UNITED STATES  
NUCLEAR REGULATORY COMMISSION  
WASHINGTON, D. C. 20555

The Commission has issued the enclosed Amendment Nos. 114, 108 and 82 to Facility Operating License Nos. DPR-33, DPR-52 and DPR-68 for the Browns Ferry Nuclear Plant, Units 1, 2 and 3. These amendments are in response to your application dated April 30, 1982 (TVA BFNP TS 173) and supplemented by a letter dated June 10, 1982.

Amendment No. 108  
License No. DPR-52

SAFETY EVALUATION BY THE OFFICE OF NUCLEAR REACTOR REGULATION  
SUPPORTING AMENDMENT NO. 114 TO FACILITY OPERATING LICENSE NO. DPR-33

Fig. 4.2-1

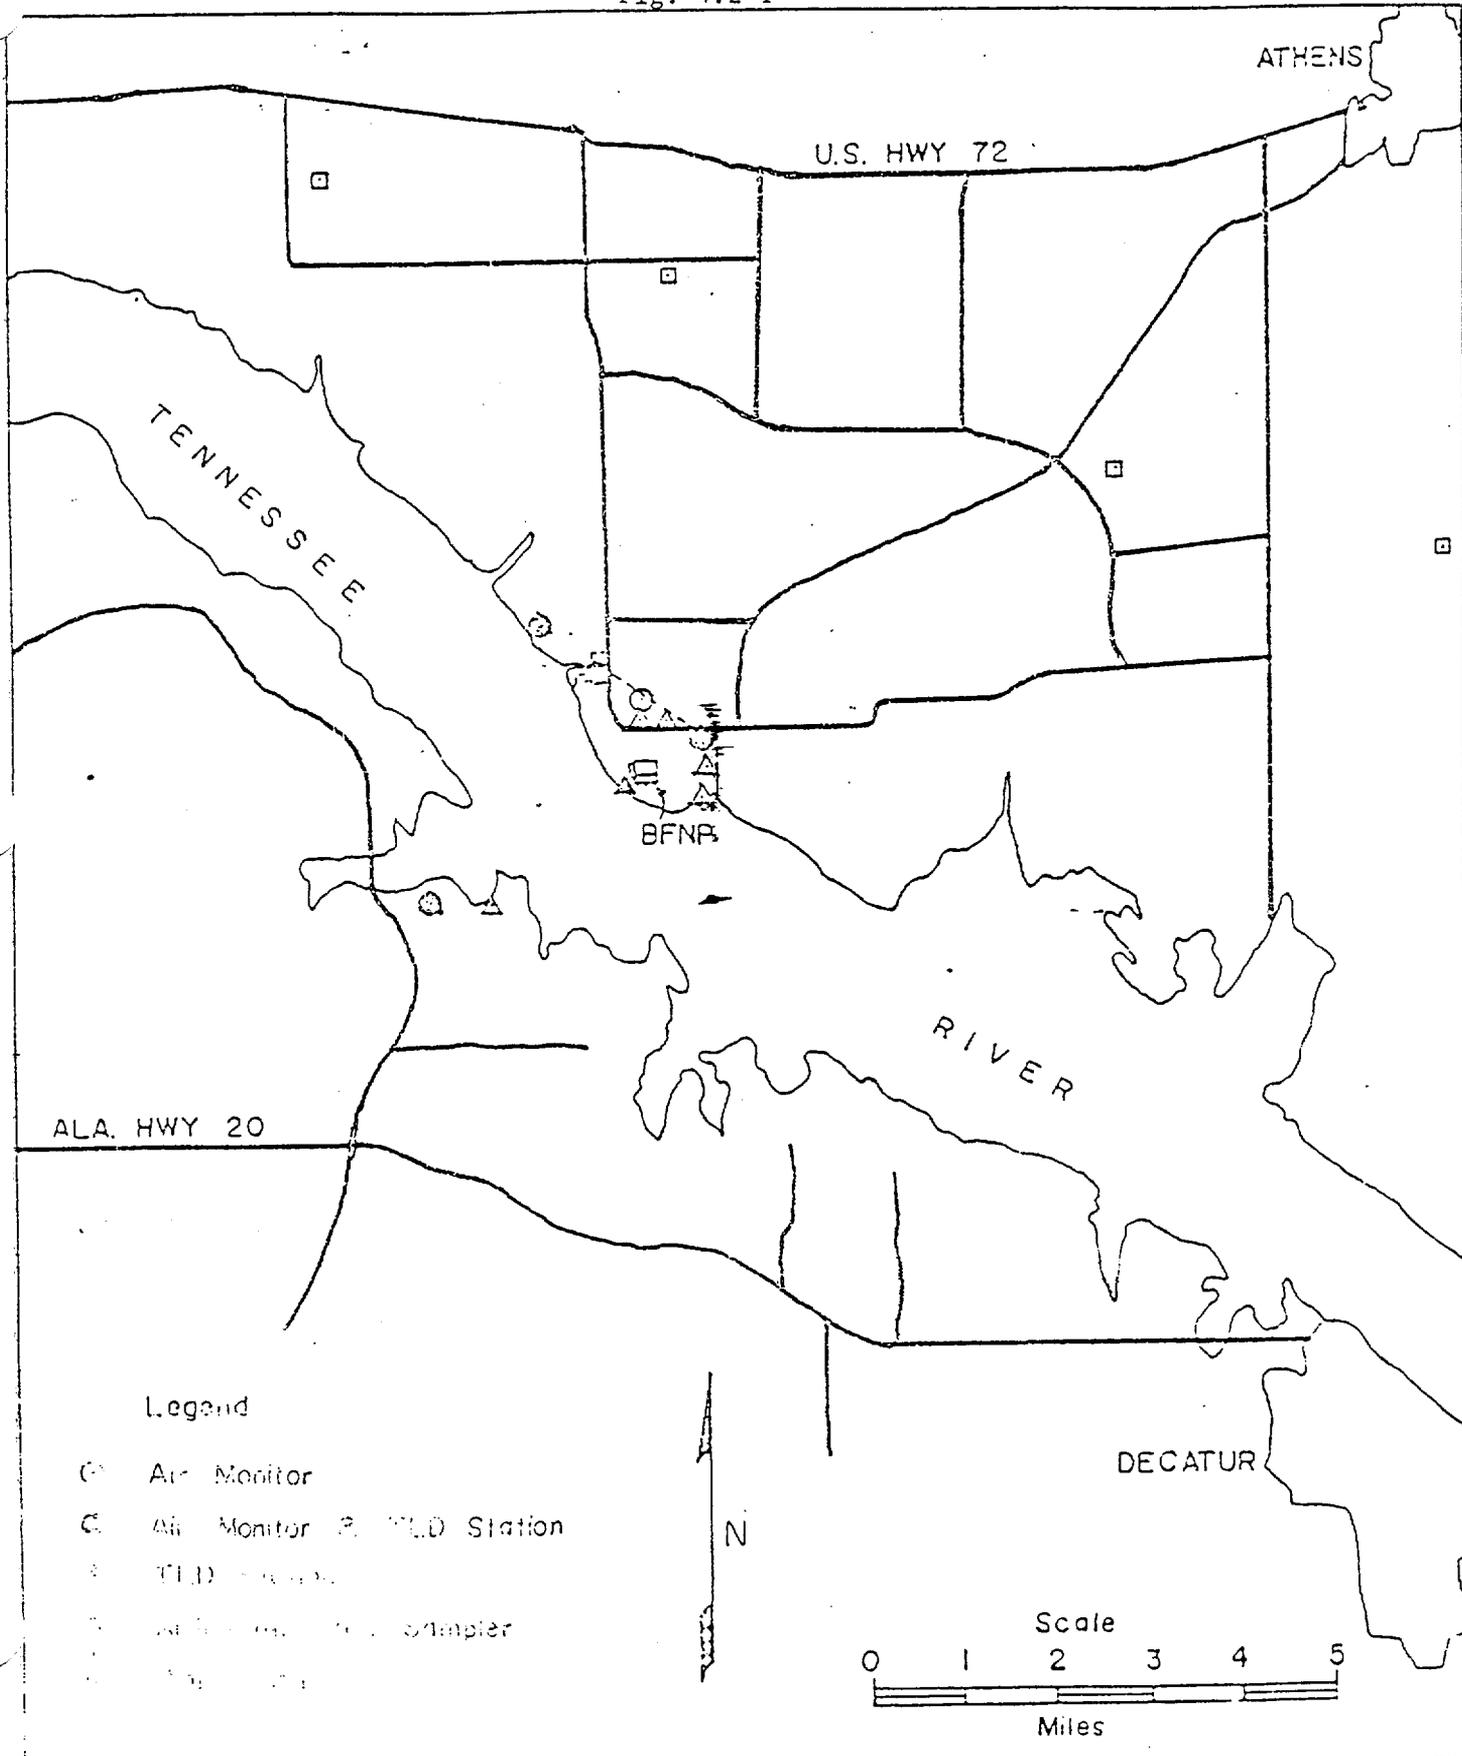
Environmental Technical Specifications (Appendix B) Paragraph 4.2.3.b requires that "milk shall be collected monthly when animals are off pasture, from at least four farms in the vicinity of the plant and analyzed as indicated in Table 4.2-1 and figure 4.2-1." Figure 4.2-1 depicts five dairy farms.

The licensee has requested a change to the figure deleting two of the dairy farms and adding a new one, stating that the two deleted sampling points no longer have milk producing animals. This change is acceptable based on the need to have four locations with milk producing animals.
